IEEE P802.11
Wireless LANs

Optimized Bit Order within the Interleaver

Date: February 18, 1999

Abstract

Figure 1 Current deinterleaver for QAM16

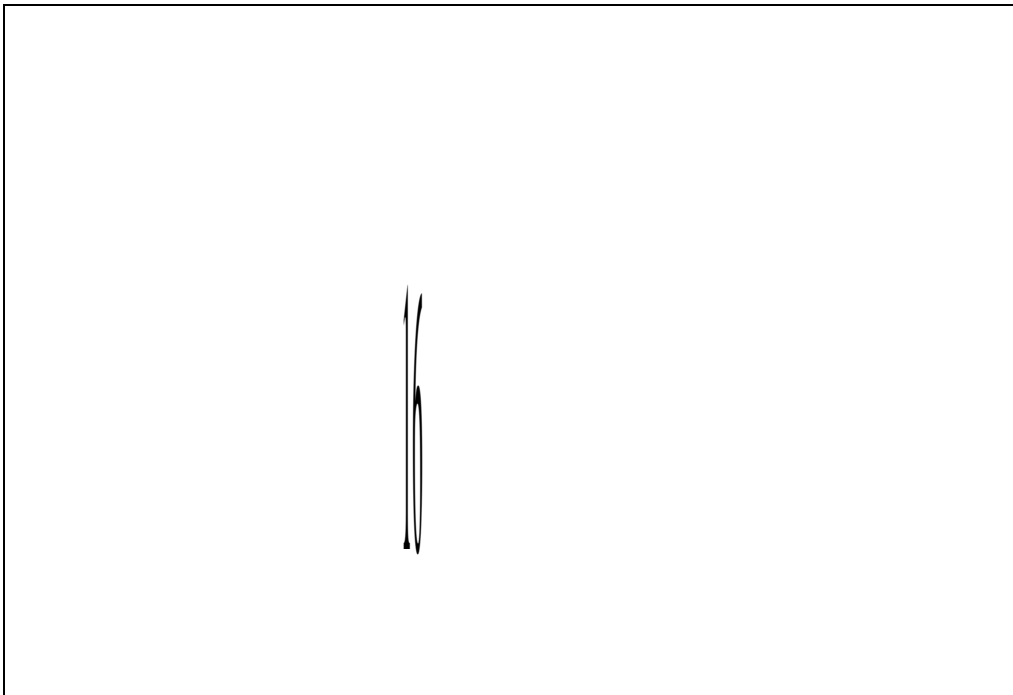
As can be seen, the bit stream leaving the deinterleaver, is composed of 16 consecutive high-reliability MSBs followed by 16 consecutive low-reliability LSBs. This may weaken the error correction capabilities of the convolutional code.

The proposed solution is to cyclically permute all the bits that relate to the same coordinate. The contents of the deinterleaver for QAM16, under the proposed permutation is shown in figure 2.
